CERTIFICATE OF APPROPRIATENESS

Property: 1516 Harvard Street, Lot 16, Block 139, Houston Heights Subdivision. The

Proposal: Alteration: Rear Addition and New Garage

ITEM #E15 1516 Harvard St Houston Heights East

Rear (East) Elevation - Proposed

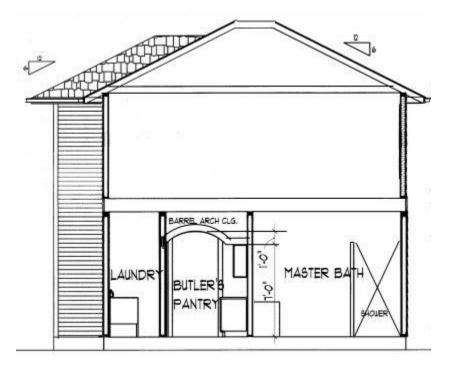
Recommendation: Approval with conditions: On front elevation of proposed rear addition, install two,

inset and recessed, single- or double-hung, wood or aluminum windows.
